## **Customer Notification**

# **V850E/PH2**

## **Operating Precautions**

**μPD70F3187**

No. 2	TMP/TMT/TMR: Event counter mode shorts first output pulse (Specification change notice)
-------	--

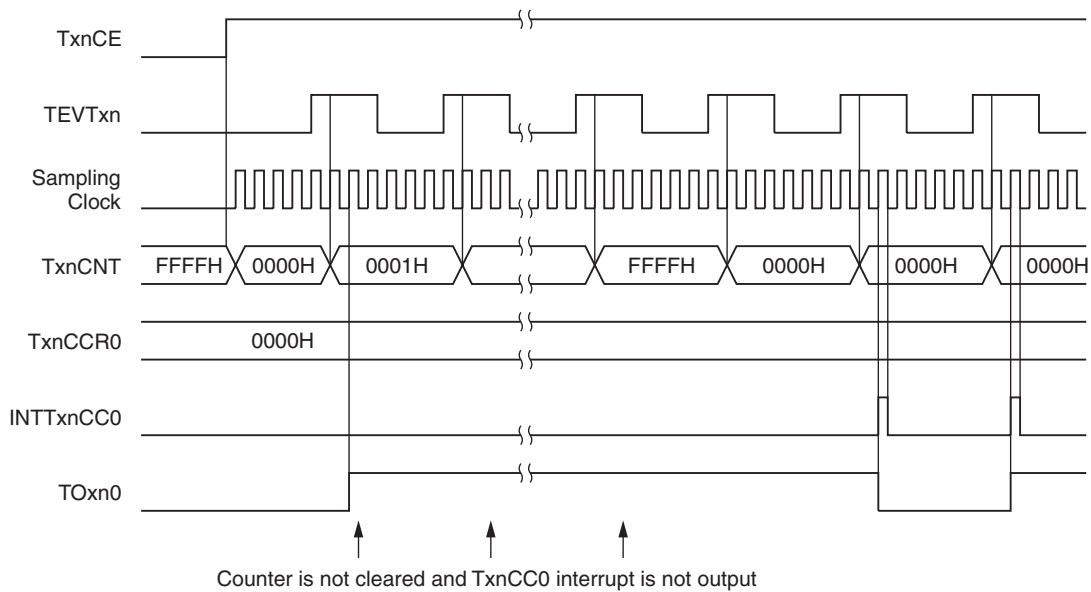
If timer P (TMP), timer T (TMT) or timer R (TMR) uses a timer output in event-mode, the pulse width of timer output is different in the first period.

The diagram illustrates the timing of a timer output in event mode. It shows several signals: TxnCE (enable), TEVTnx (external clock), Sampling Clock, TnxCNT (counter value), TnxCCR0 (compare register), INTTnxCC0 (interrupt), and TOxn0 (output pulse). The counter starts at FFFFH and then counts up from 0000H to 0002H. The output pulse width is shown to be different in the first period (width of 2 counts) and subsequent periods (width of 3 counts).

Do not use timer outputs in external event count mode. Instead of this use the interval mode with enabled external clock input (TEVTnx) by setting the TxnEEE bit of the TxnCTL1 register to 1.

No. 3	TMP/TMT/TMR: External event counter mode does not work correctly when compare register value is 0000H (Specification change notice)
-------	--

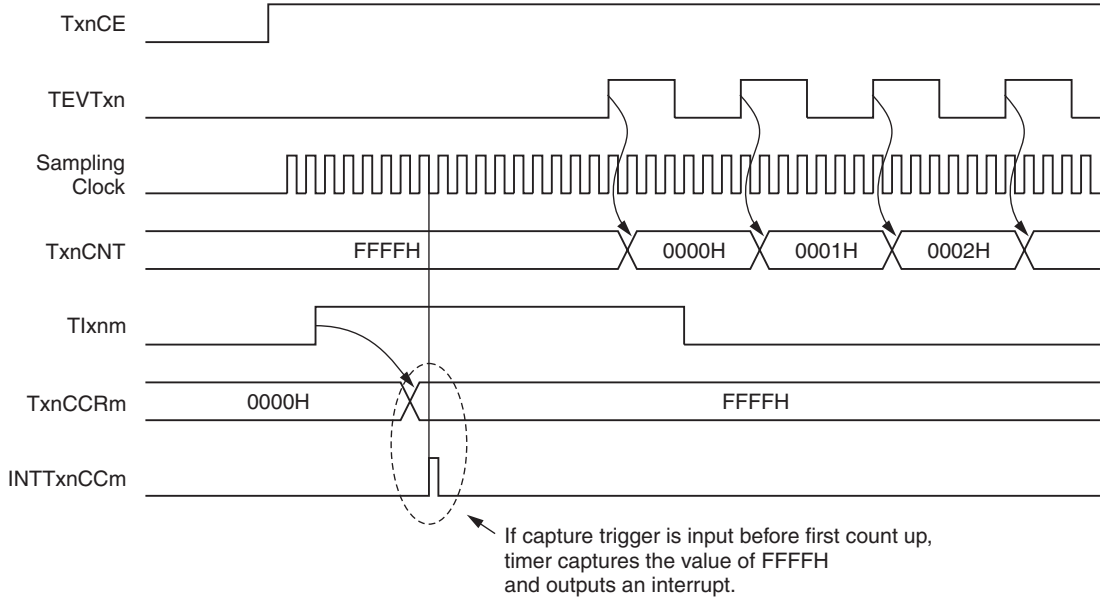
In the external event count mode (TxnMD3 to TxnMD0 bits = 0001B) the counter (TxnCNT) is not compared with the compare register value (TxnCCR0) during first count up timing. Therefore, when TxnCCR0 is set to 0000H, the counter cannot be cleared and the compare match interrupt signal (INTTxnCC0) is not output. In this case the timer counts up until FFFFH in the first period, and not until then the compare match works as expected.

TxnMD3 to TxnMD0 bits = 0001B (External event count mode), TxnCCR0 = 0000H

Do not set TxnCCR0 = 0000H in external event counter mode.

No. 7	AFCAN: Rx limitation (Technical limitation)
-------	--

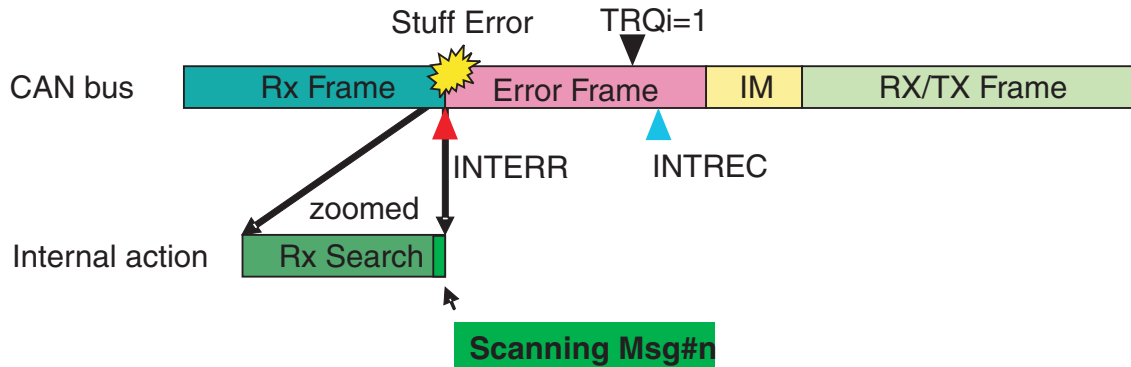
2. Behavior without pending TRQ (TRQi = 0)

In case the host processor has not submitted a transmit request (TRQ) for any buffer before the detection of the bus error but submits TRQ = 1 after that point in time (see figure below) before the re-transmission of the message interrupted by the stuff bit error started, the unexpected reception of the message will take place.

The unexpected storage of the message is issued in the particular message buffer that matches the acceptance filter criteria at the time where the bus error is detected (as described in 1.) or the message buffer #0 is overwritten independently of its configuration.

NEC will update the affected products.

NEC does not recommend a S/W workaround as first choice as it is fairly complex. On the one hand it is based on the control of workmitting transmission requests only when the bus is idle. On the other hand a less complex algorithm can be used which does not prevent the unexpected reception but detects it safely and discards the unexpected reception in the CAN S/W driver. Any of these algorithms require that message buffer #0 is not used or that a 'dummy' TRQ in an unused buffer is set. This prevents behaviors as described in 2.

No. 9	CSIB: Subsequent transfer in single transfer mode may fail (Specification change notice)
-------	---

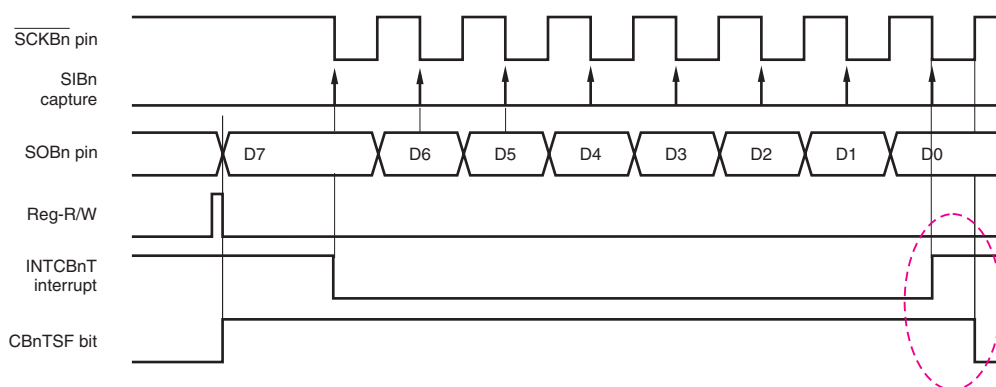
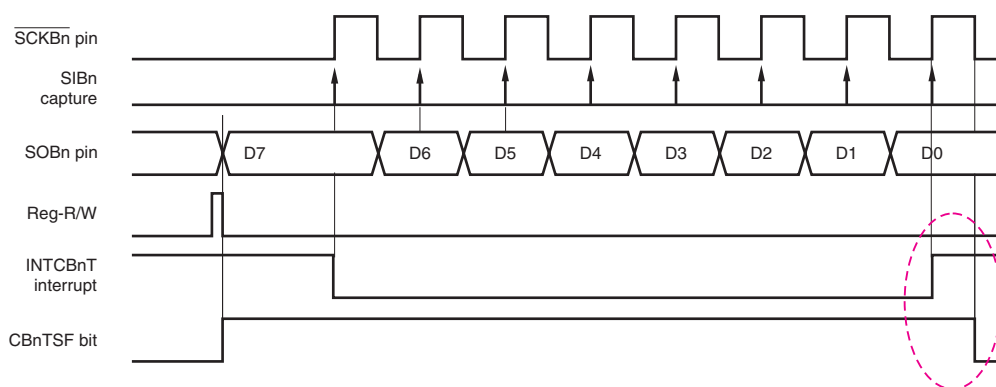
In the case single transfer mode and CBnDAP=1, transmission enable interrupt (INTCBnT) occurs at the sampling timing of the final data bit.

Next transfer operation begins by writing to CBnTX register after finishing transfer. (It is not permitted to start next transfer by writing CB0TX register during data transfer.)

When CBnTSF = 1 after transmission enable interrupt (INTCBnT) occurred, writing next data to CBnTX register for a subsequent transfer may not start next transfer.

Therefore, if DMA is used, depending on transfer clock and access speed on the special function registers, the transfer operation may fail.

In single transfer mode, when CBnDAP=1, check whether the CBnTSF flag is cleared (0) or not. If CBnTSF flag = 0, write next transfer data to CBnTX register.

If DMA transfer function is used, only transfer modes with CBnDAP=0 should be used.

Figure: Additional Measures in case AFCAN clock is active when waking up

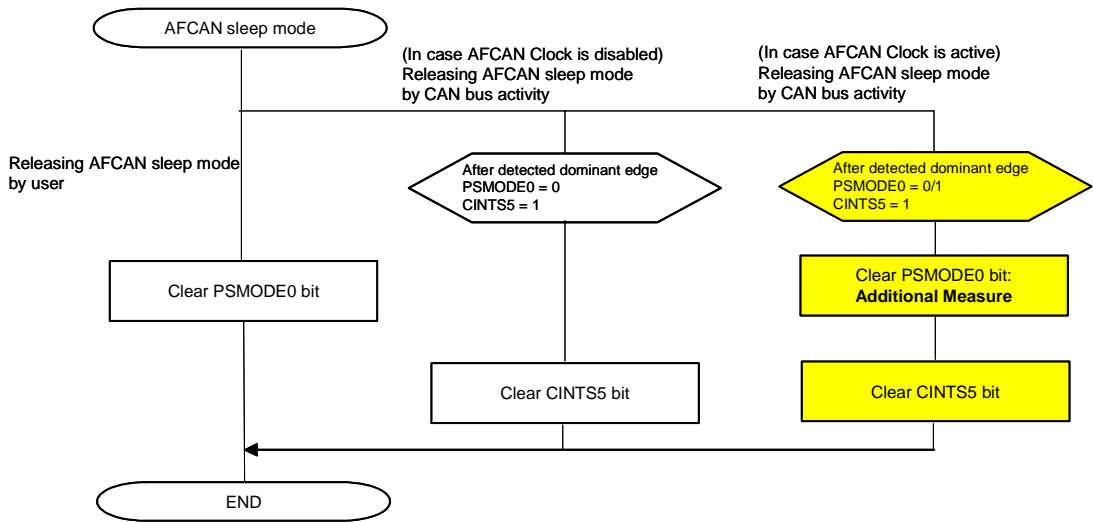
The following flowchart illustrates, how and whether additional measures have to be taken in software, to avoid the *wakeup dead time*.
